DEPARTMENT OF THE ARMY TECHNICAL MANUAL

**ARMAMENT SUBSYSTEM,
HELICOPTER, 7.62 MILLIMETER
MACHINE GUN: HIGH RATE,
XM27E1 (1005-933-6242) (USED ON
OH-6A HELICOPTERS)**

**This copy is a reprint which includes current pages from Changes 1
through 3**

TM 9-1005-298-34, 30 July 1969, is changed as follows:

Figure 3-4. Delinking feeder MAU-56/A-exploded view (sheet 1 of 2)

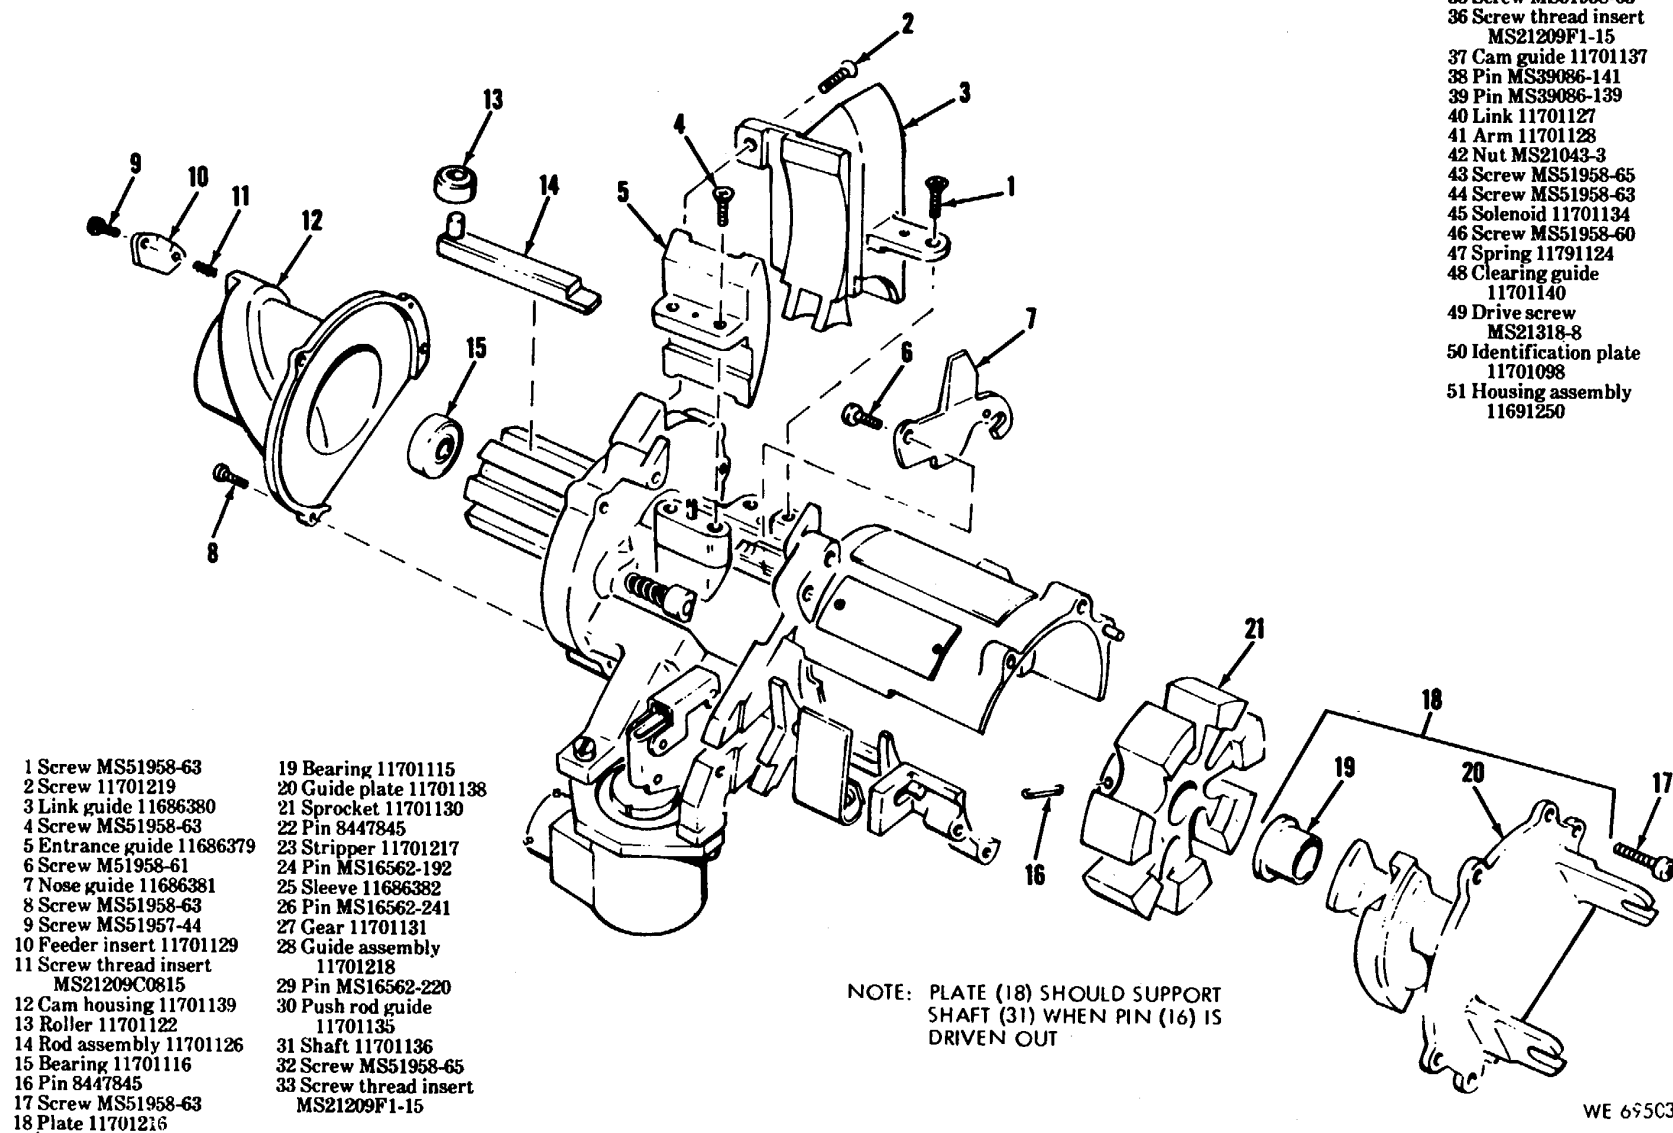
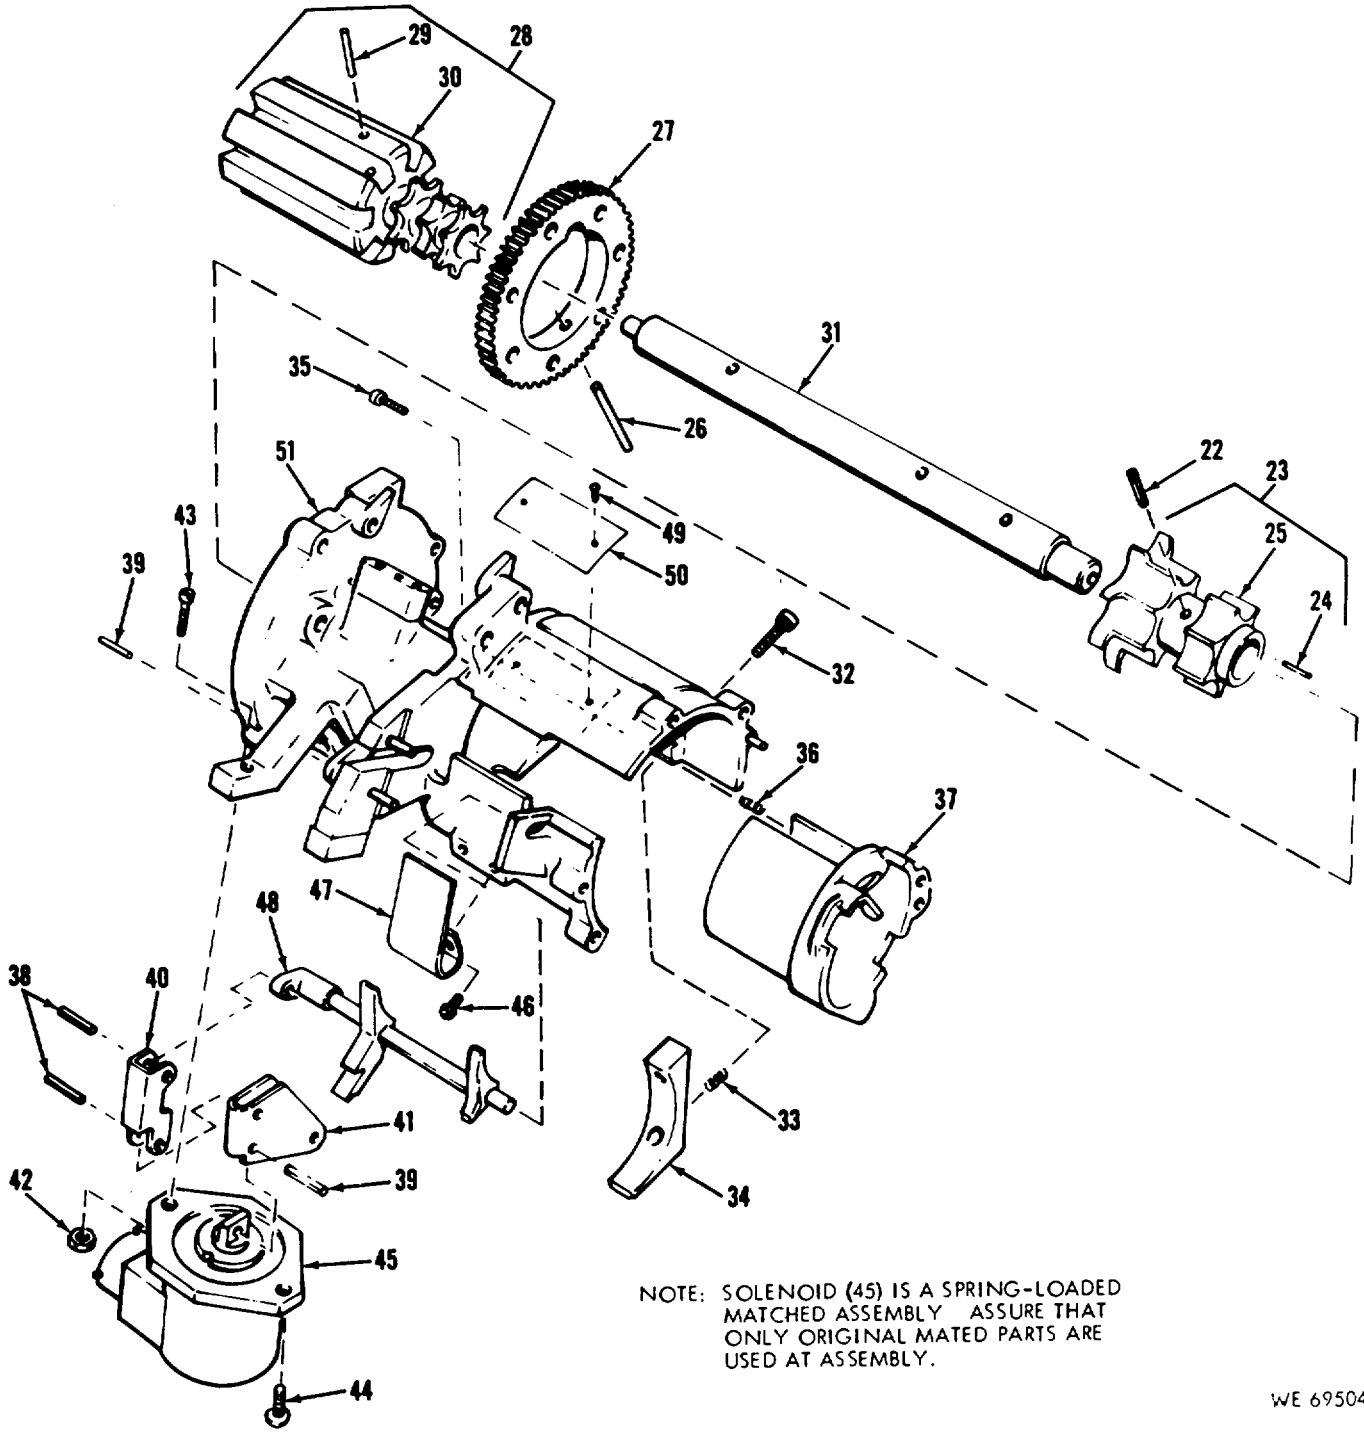
a. *Disassembly.* Refer to the numerical sequence in figures 3-4 and 3-4.1 and the following specific instructions for disassembly of the feeder and feeder housing assembly.

(1) Drive out pin (14, fig. 3-4) while plate (18) is still in place to support shaft (31).

(2) If pin (26) is badly bent and difficult to drive out, the following method of removal may be used.

(3) When removing spring-loaded solenoid (45) assure that all matching parts are kept together for installation as a unit.

Pages 3-6, 3-7, and 3-8. Figure 3-4 is superseded as follows:

b. *Assembly.* Assembly of the feeder and feeder housing assembly is in reverse order of disassembly and the following instructions.

Solenoid (45) consists of matched parts. Use only as a unit. Interchange of solenoid parts may result in a firing system malfunction.

(2) Install solenoid (45) using only matched parts.

(3) Install pin (29) with approximately 1/8 inch protruding.

(4) Use 3/16 inch punch and align holes in gear (27), push rod guide (30), and shaft (31) so that a slot in guide is opposite point where punch enters gear.

(5) Hold gear (27) - push rod guide (30) - shaft (31) unit firmly, remove punch and install pin (26) through unit. Pin shall not protrude into slot of guide nor restrict gear tooth action.

(6) Install stripper (23) to shaft (31) with pin (22) entering from slot aligned hole in stripper. Pin shall be flush with surface of stripper.

(7) Press bearing (19) into guide plate (20) until flange of bearing is flush with surface of plate.

(8) Slide sprocket (21) onto shaft (31) so that alignment pin (24) of stripper (23) engages recess in

(9) Install pin (16) in sprocket (21) so that pin is flush with surface of sleeve.

(a) Rotate sprocket (21, fig. 3-4) and shaft (31) to check for smooth operation.

(b) Check sprocket (21) and gear (27) to assure that there is no end play on shaft (31).

(c) Slide a round of ammunition through each opening (slot) in sprocket (21) and observe that there is no catching or binding.

(d) Check that clearing solenoid (45) is operating smoothly.¹

NOTE: SOLENOID (45) IS A SPRING-LOADED MATCHED ASSEMBLY. ASSURE THAT ONLY ORIGINAL MATED PARTS ARE USED AT ASSEMBLY.

Figure 3-4. Delinking feeder MAU/56-A-exploded view (sheet 2 of 2)

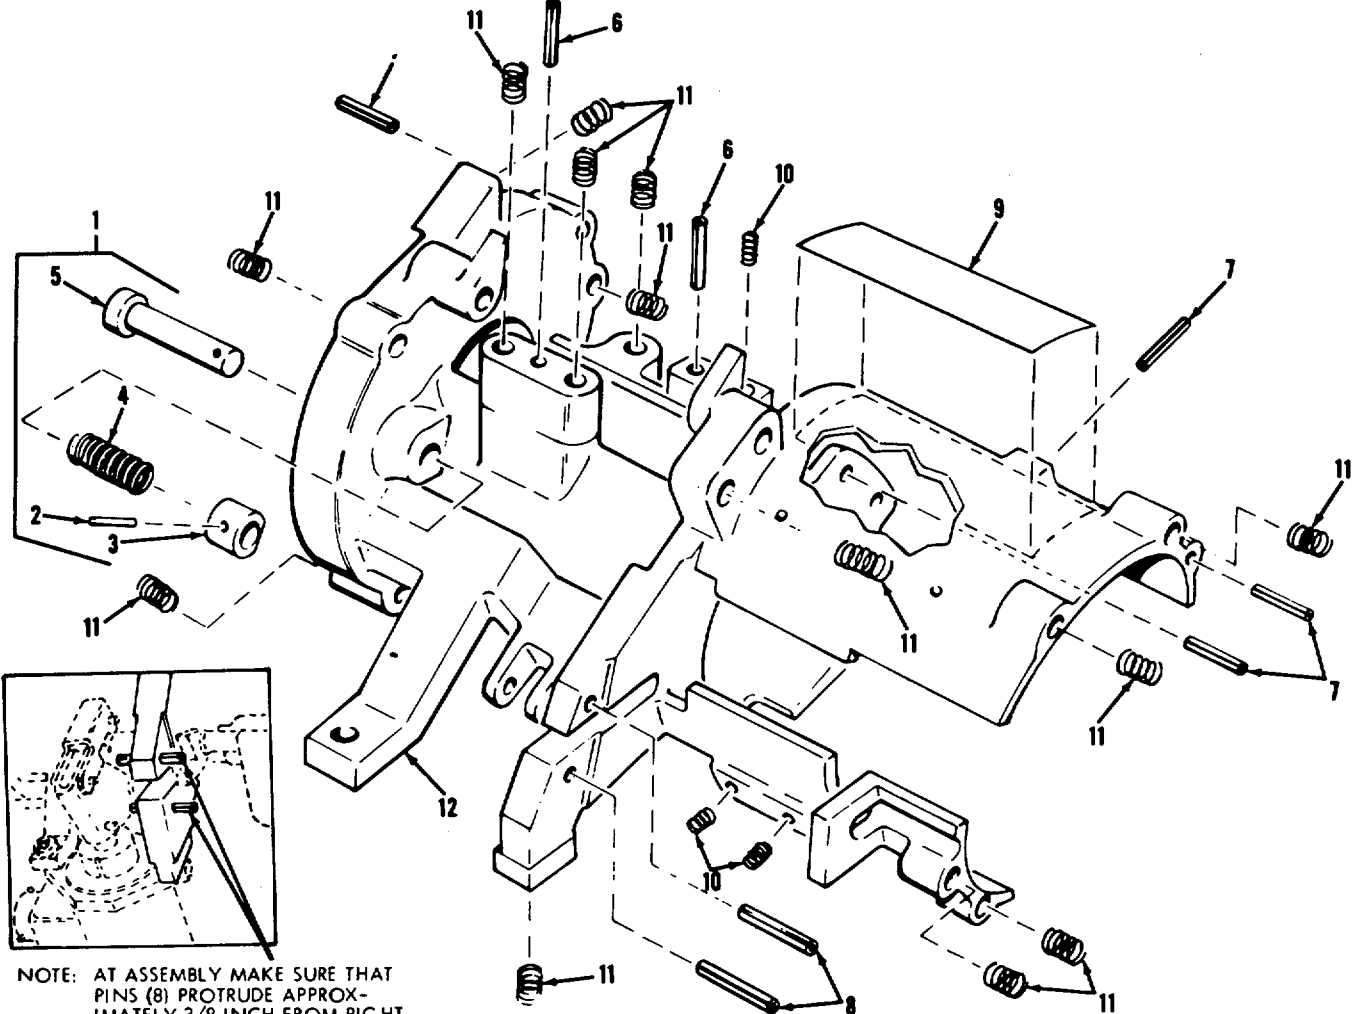
Prior to installation of instruction plate (9, fig. 3-4.1) adhesive on back shall be activated by use of acetone, methyl-ethyl-ketone, or methyl-isobutyl-ketone.

(10) Clean surface to receive instruction plate (9, fig. 3-4.1) so that it is free of oil, dirt, grease or other contaminants that could impair adhesion. Activate adhesive on back of plate and install on housing (12) using firm overall pressure.

(11) Install pins (8) so that approximately 3/8 inch protrudes on side toward instruction plate (9).

NOTE: AT ASSEMBLY MAKE SURE THAT PINS (8) PROTRUDE APPROXIMATELY 3/8 INCH FROM RIGHT SIDE OF HOUSING.
